Plug and Abandonment - NOI

Hill 4

API # - 3004523307

Re: Permanent Abandonment
Well: Hill 4

Proposed Schematic

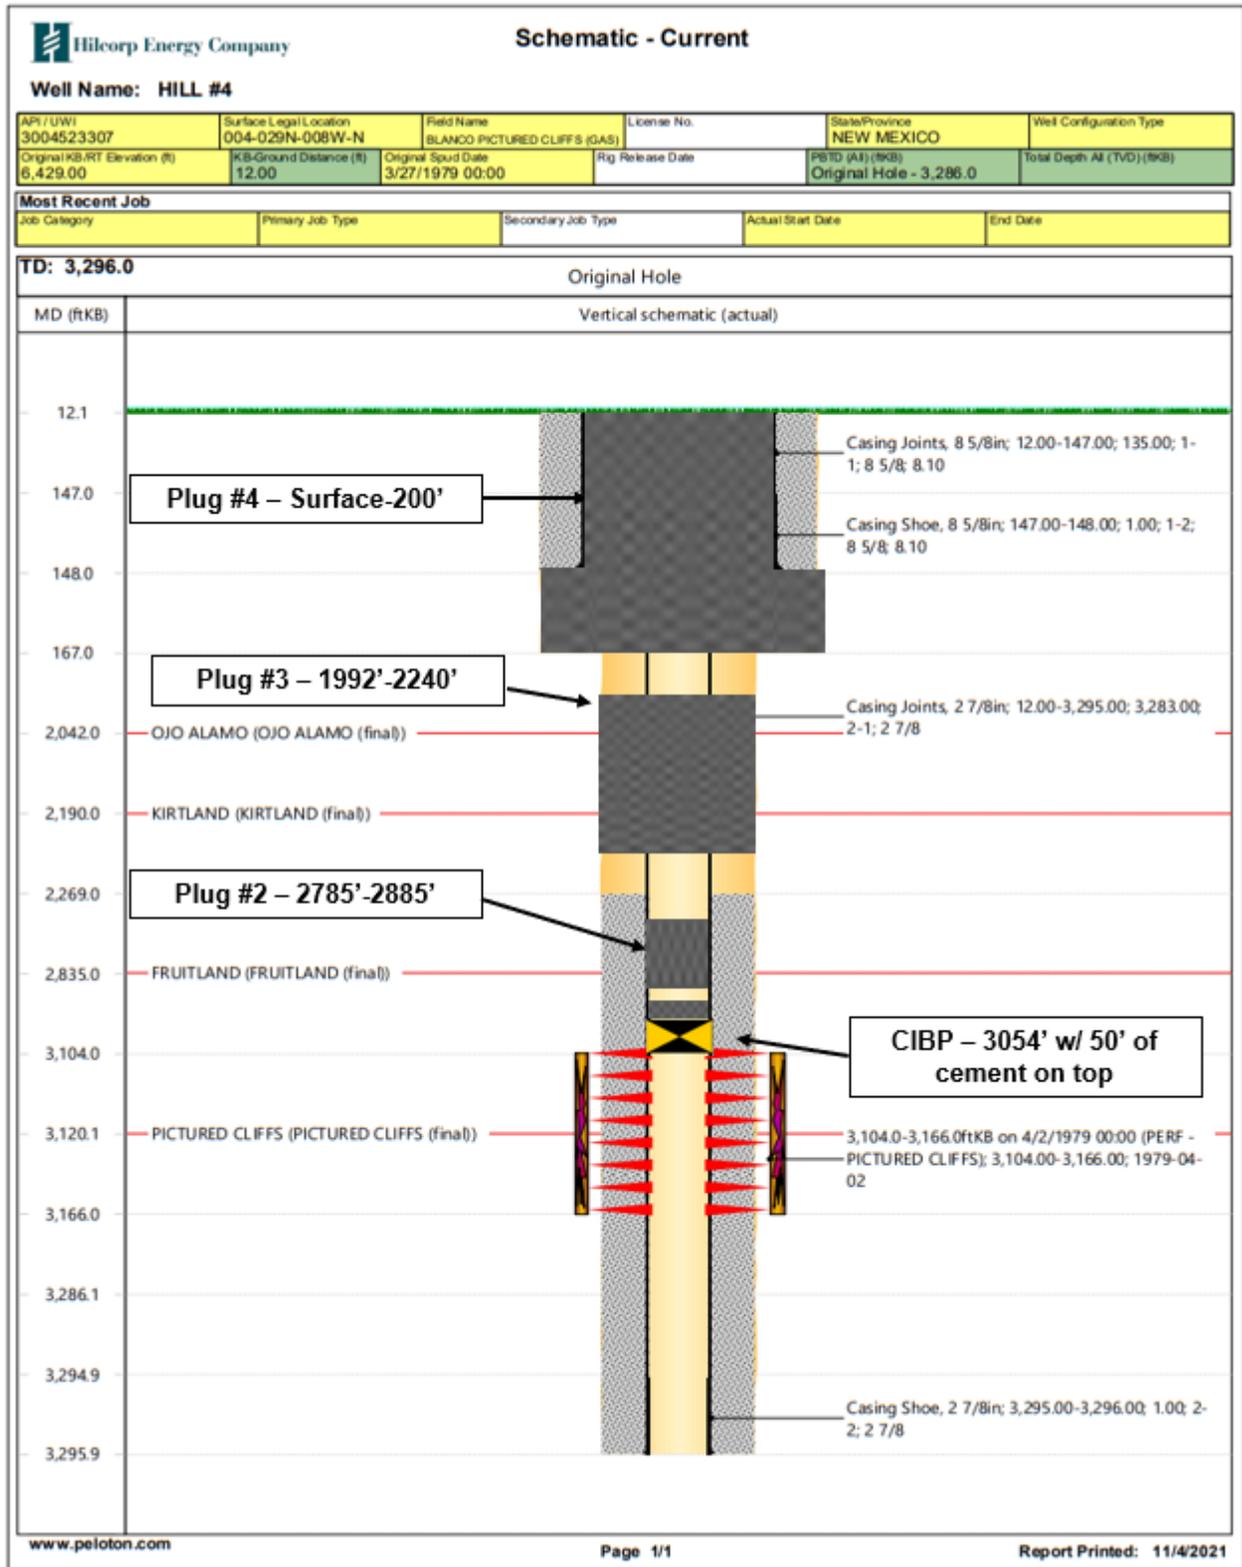
1. Plugging operations authorized are subject to the attached "General Requirements for Permanent Abandonment of Wells on Federal and Indian Lease."
2. Farmington Office is to be notified at least 24 hours before the plugging operations commence (505) 564-7750.
3. The following modifications to your plugging program are to be made:
 - a) Bring the top of Plug No. 2 (Fruitland) up to 2700' to cover BLM pick.

- BLM pick for the top of the Fruitland formation varies from Operator pick.

- Bring the top of Plug #2 (Fruitland) up to 2700' to cover BLM pick.
